# Planning Officer Report

## 134-160 Spencer Street, Melbourne

Planning Permit Application no. 2014/003203

**Figure 5**

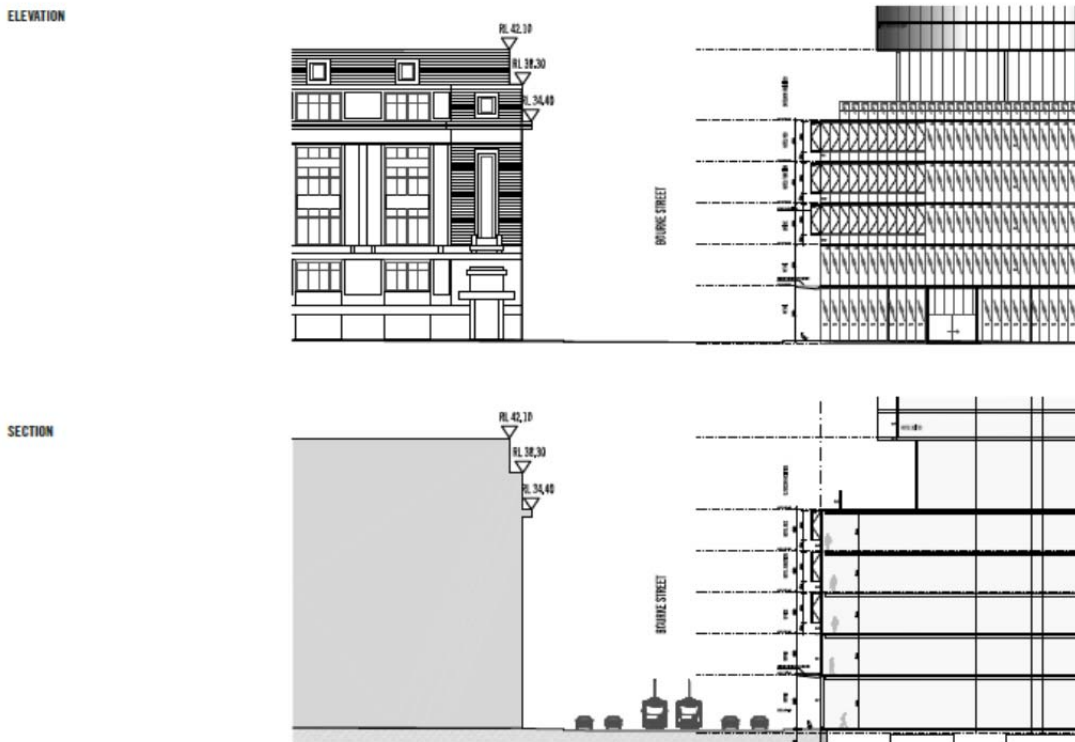
The proposed tower will be setback 8 metres from the Bourke Street frontage with the east and west end curved points reducing further to 6 metres. While reduced from the 10 metres encouraged by policy, these setbacks expressed in an articulated, curved façade, together with the height of the podium are considered

to provide an appropriate transition between the height of the tower and the pedestrian scale of the street as illustrated in the above perspective image (see Figure 5).
